Airstream Atlas E1 & Interstate 24 E1 & 19 E1 Touring Coach Technical Service Bulletin #200 – Airstream and Volta E1 Package Updates

Date: 7/17/2024

Re: Technical Service Bulletin #200

Airstream & Volta E1 Package Update

Old Wiring:

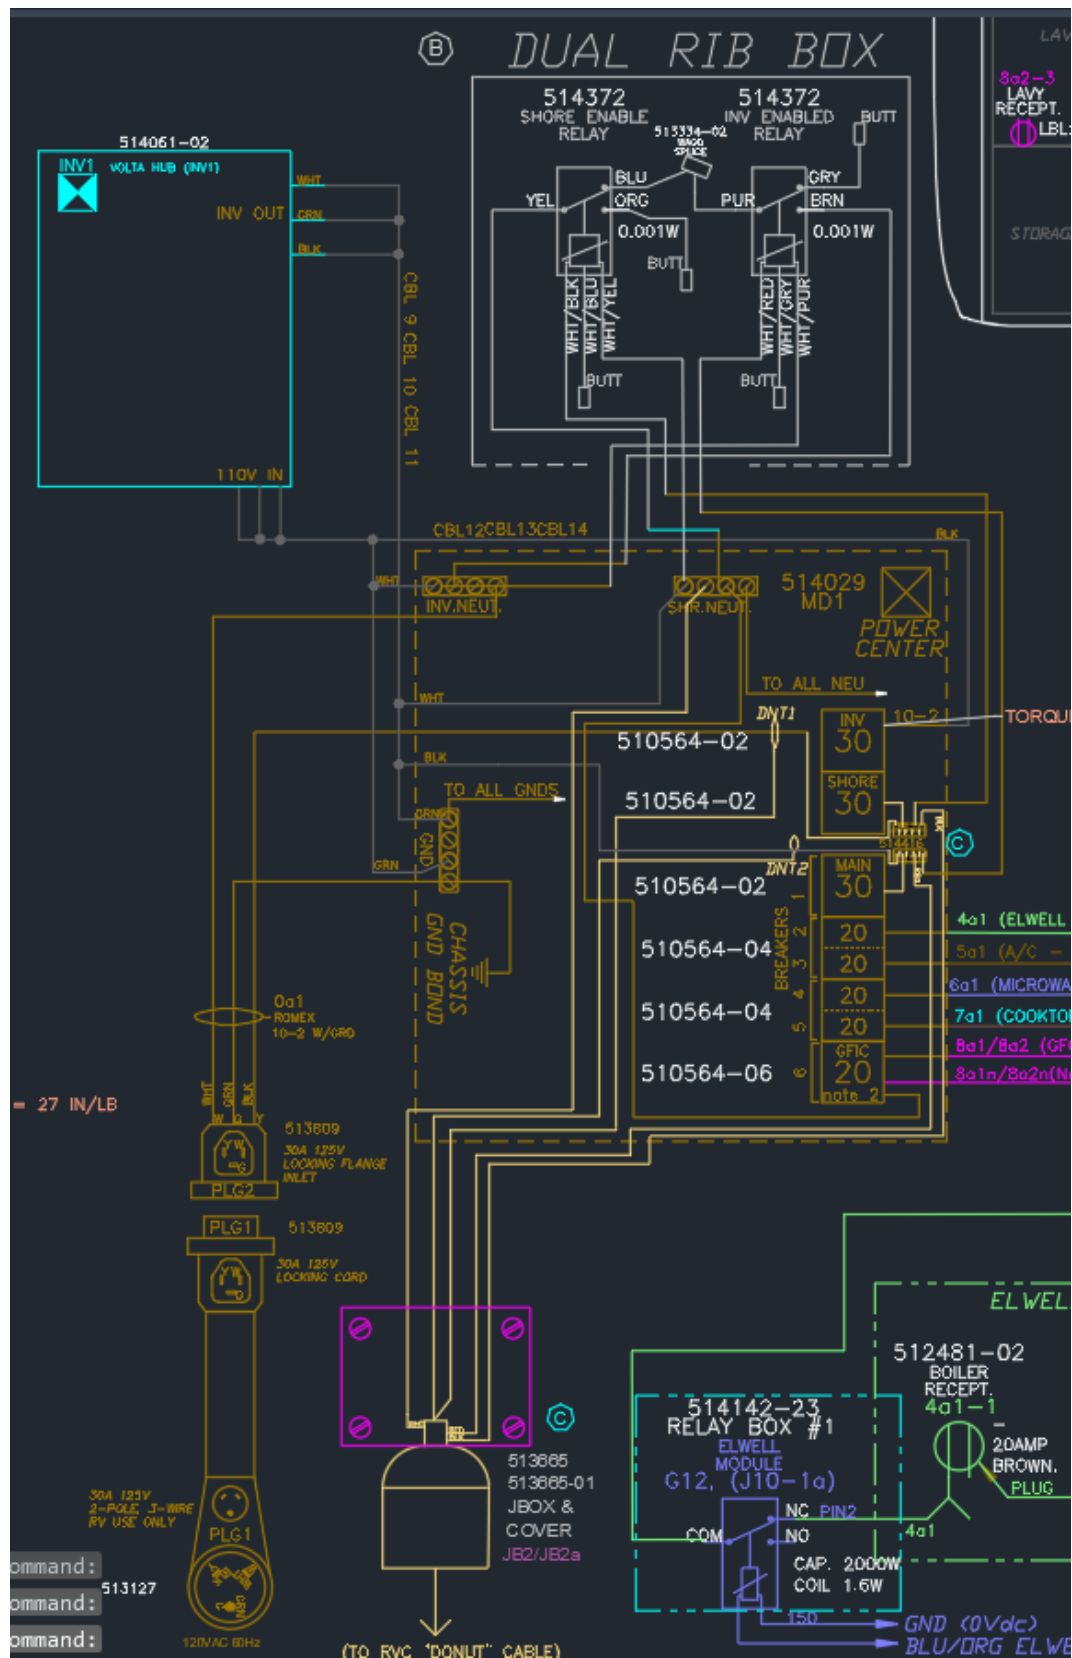
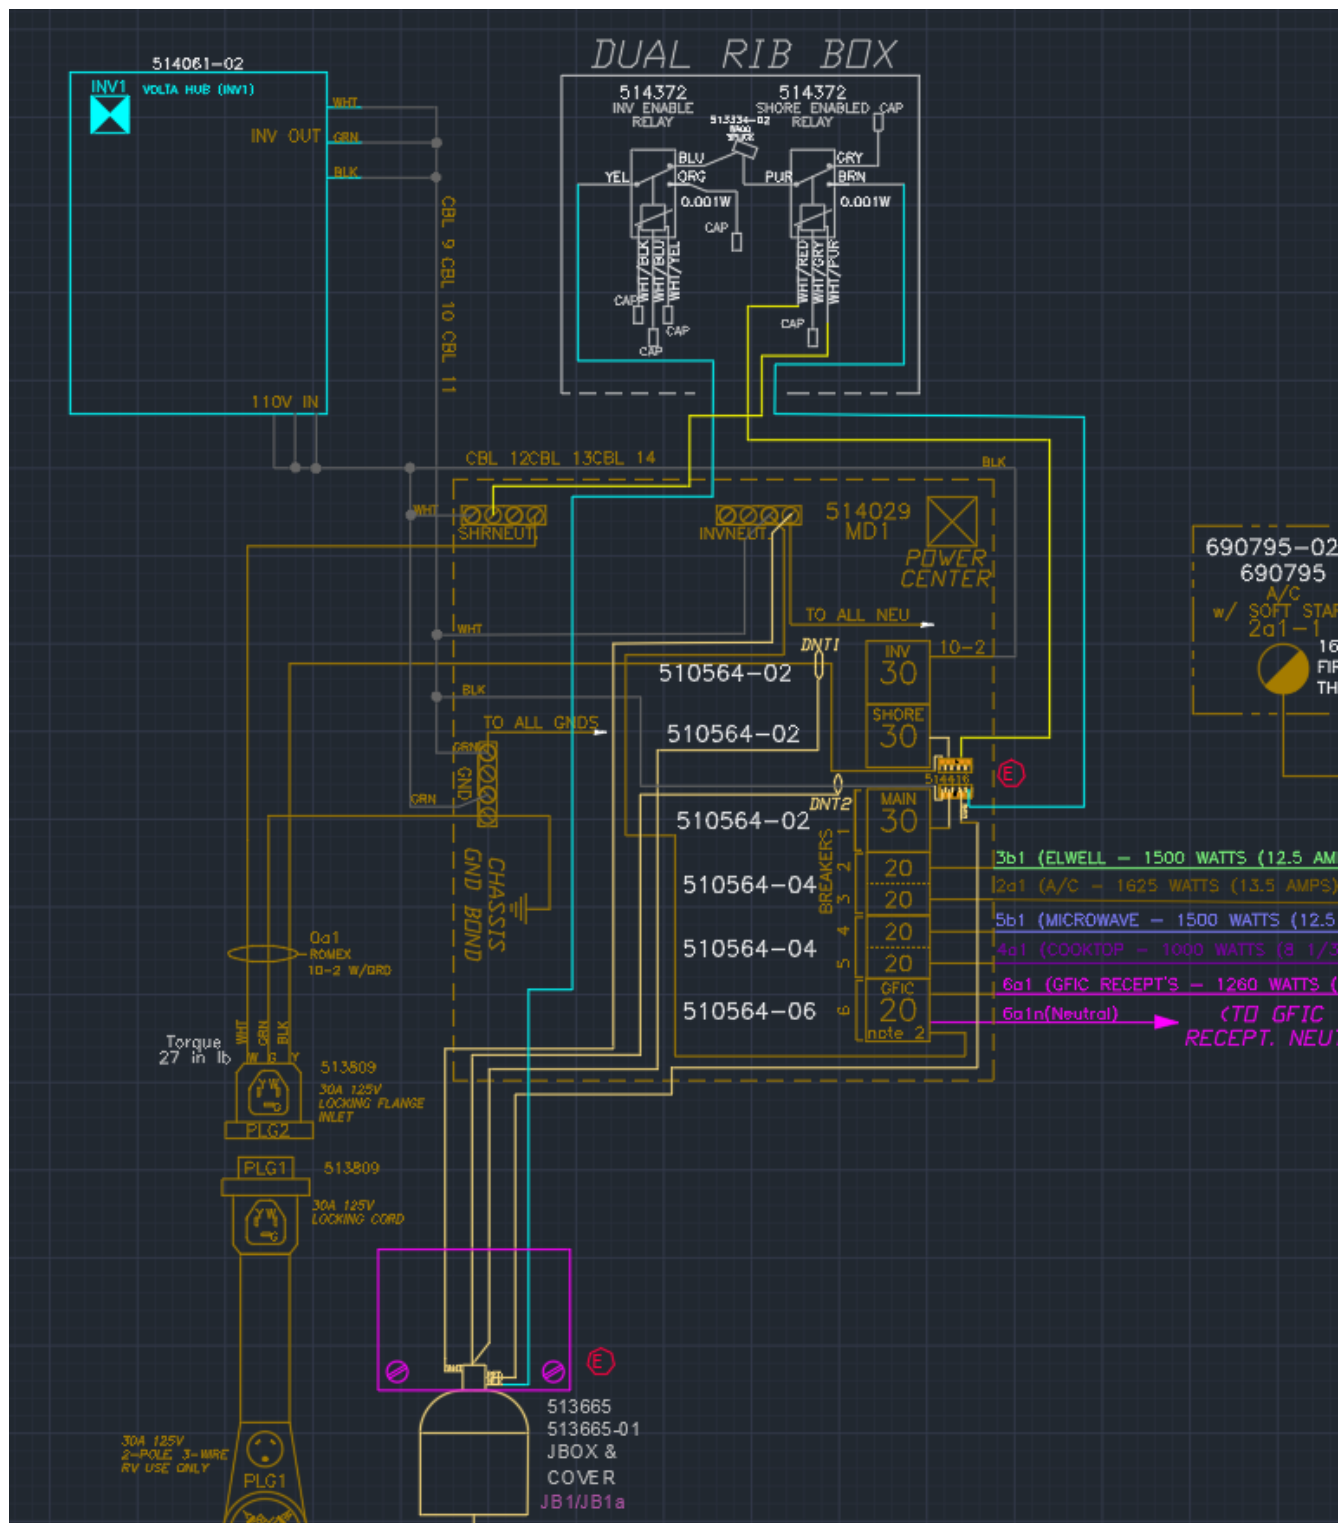
New wiring:

RIB Rewiring:

Colored Cable RIB:

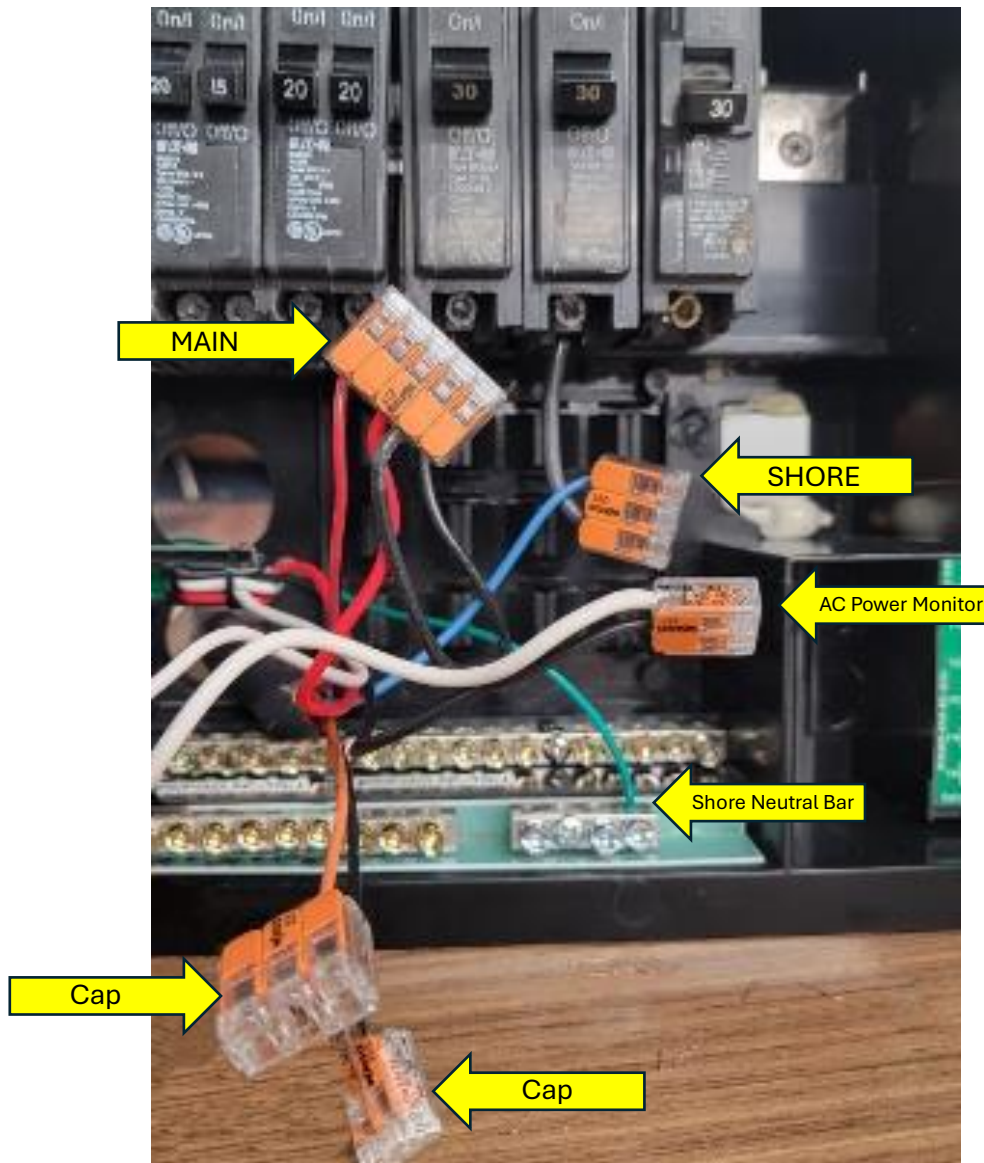
1. Disconnect all wires from the dual RIB cable.
2. Using the existing Wago, connect the White wire to the Black wire from the AC power monitor.
3. Connect the Red wire to the “MAIN” breaker Wago.
4. Connect the Blue wire to the “SHORE” breaker Wago.
5. Connect Green wire to the shore neutral bar.
6. Cap off any remaining wires.

Blue Cable RIB:

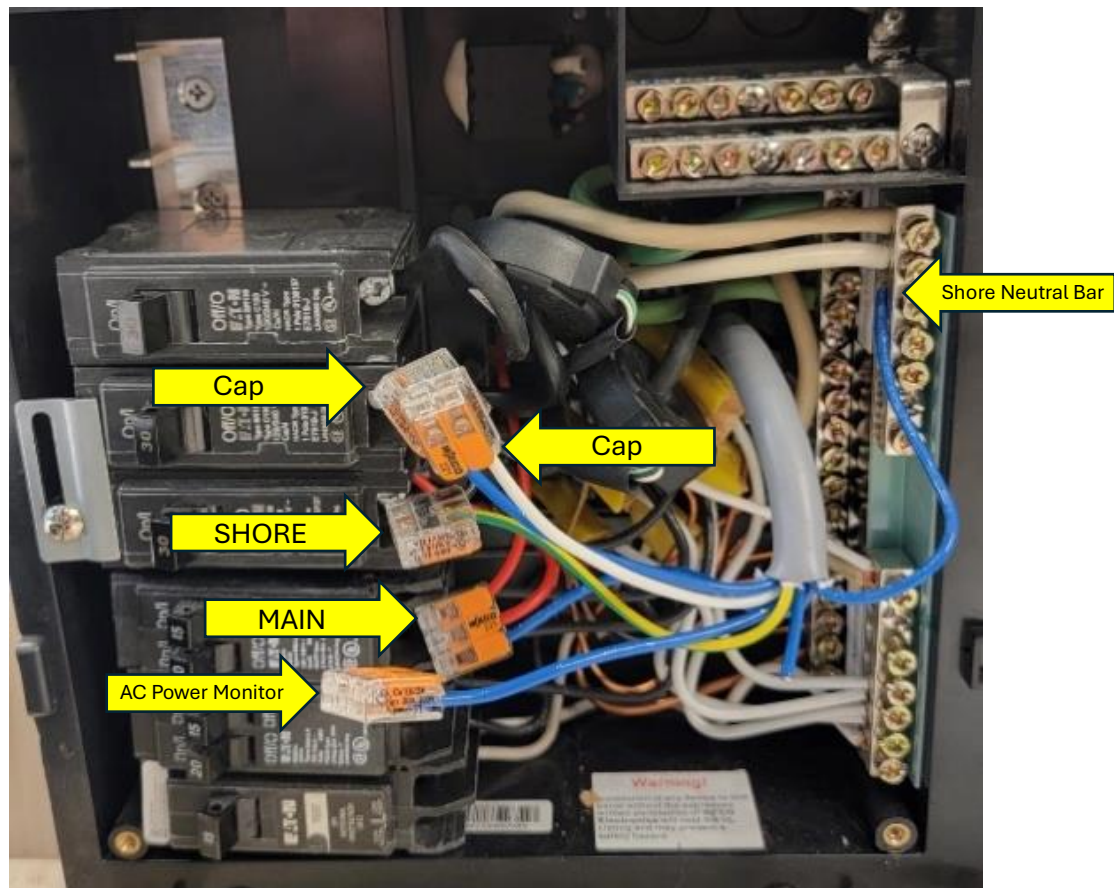
1. Disconnect all the wires from the dual RIB cable.
2. Using the existing Wago, connect the Blue 1 wire to the Black wire from the AC power monitor.
3. Connect the Blue 4 wire to the “MAIN” breaker Wago.
4. Connect the Yellow/Green wire to the “SHORE” breaker Wago.
5. Connect the Blue 5 wire to the shore neutral bar.
6. Cap off any remaining wires.

True Dual RIB:

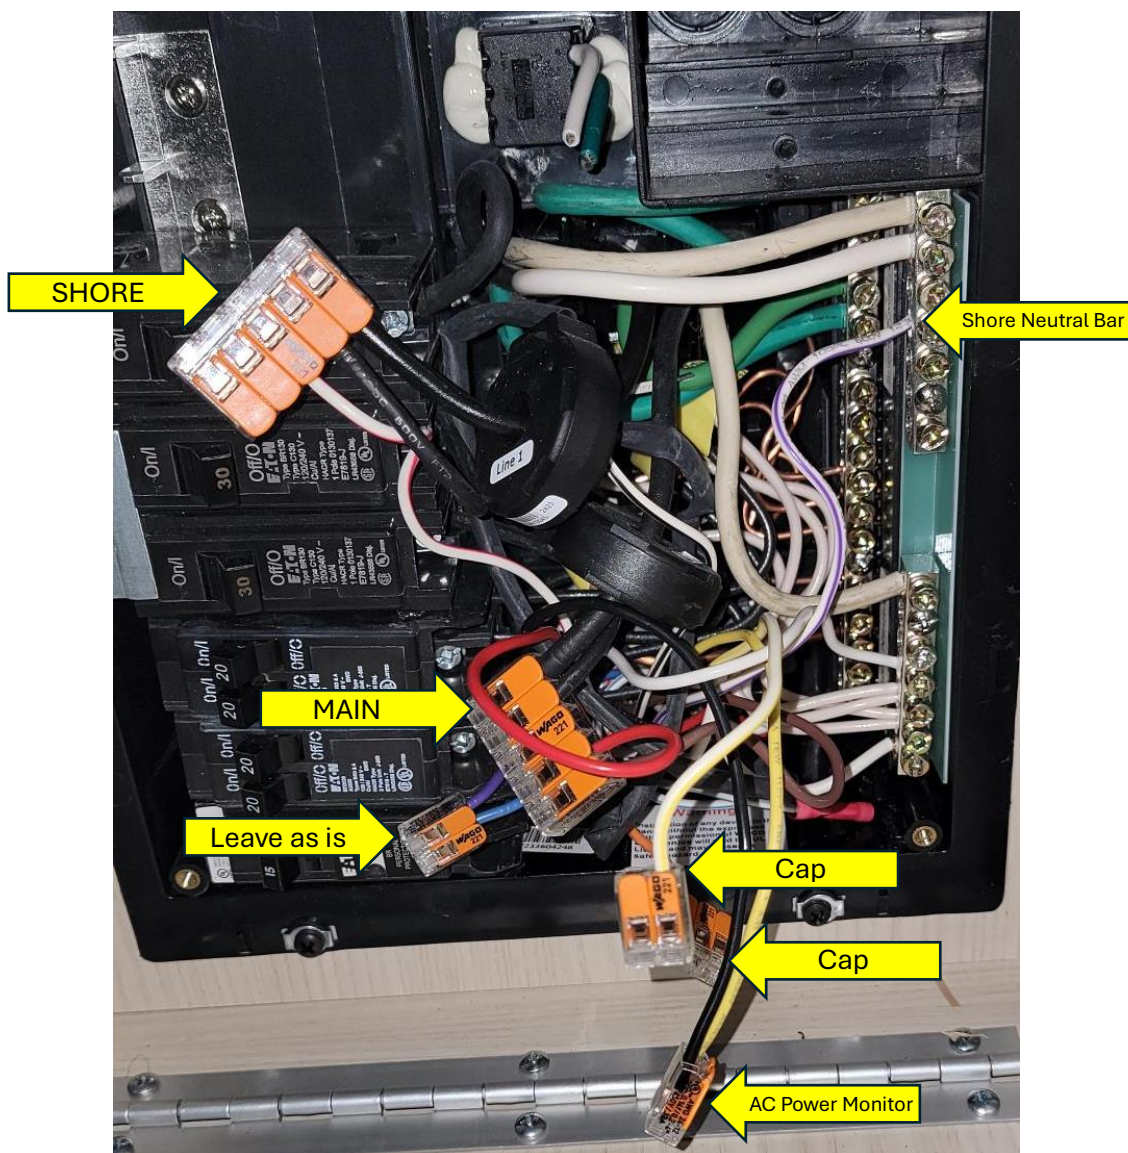
1. Disconnect all the wires from the dual RIB cable except for the Blue and Purple wires, which are connected together.
2. Using the existing Wago, connect the Yellow wire to the Black wire from the AC power monitor.
3. Disconnect the Brown wire to the “MAIN” breaker Wago.
4. Connect the White/Red wire to the “SHORE” breaker Wago.
5. Connect the White/Purple wire to the shore neutral bar.
6. Cap off any remaining wires.

Terminal Fuse

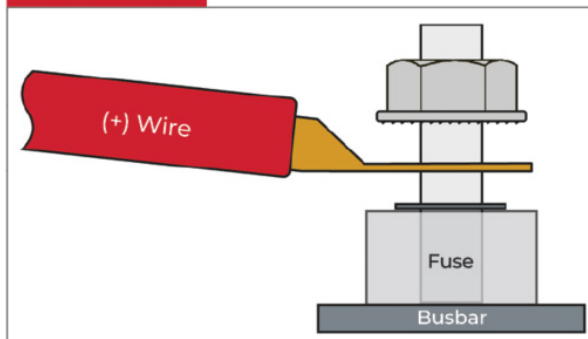
Refer to the following diagrams for internal fuse location and installation best practices. The fuse being replaced is fuse C below, with a 175A block fuse.

- A. 250A Fuse for the Volta FLEX pack.
- B. 200A Fuse for the Alternator
- C. 100A Fuse for the Inverter being replaced with 175A fuse.

175A Fuse Replace

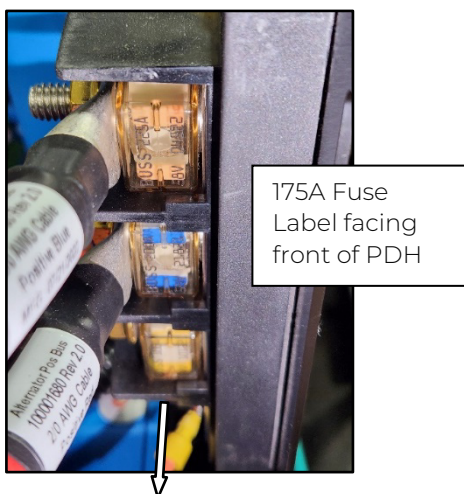
6. Place the 175A fuse on the fuse post. The fuse must be inserted with the label/coloring facing the same direction, toward the front (connection side) of the PDH (reference page 15). Otherwise, the fuses could be damaged when torquing. Fuse label in direction of wire harness.
